# Access Compliance Report Public Rights-of-Way (Curb Ramps)

Main Street: LA\_LIMONAR\_DR Cross Street: BIMINI\_DR Location: N

ADA ID: RPRK211013133816 Ramp Type: Type 1 - Perpendicular Diagonal Initial Pass/Fail: Pass Overall Compliance: No Severity Score: 20

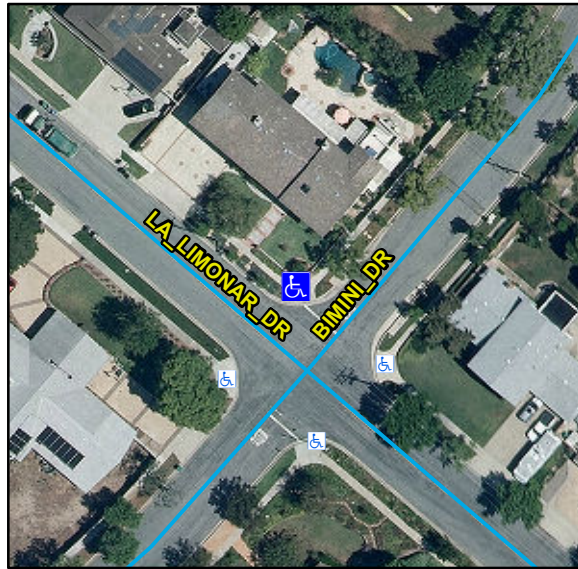
R304.2.2, R204.3, R304.2.1, R304.2.2-Perp, R304.3.2-Para, R304.5.3, R305, STD 1115

Remove & Replace Curb Ramp With Two New Directional Ramps or Equivalent. Remove & Replace Gutter.
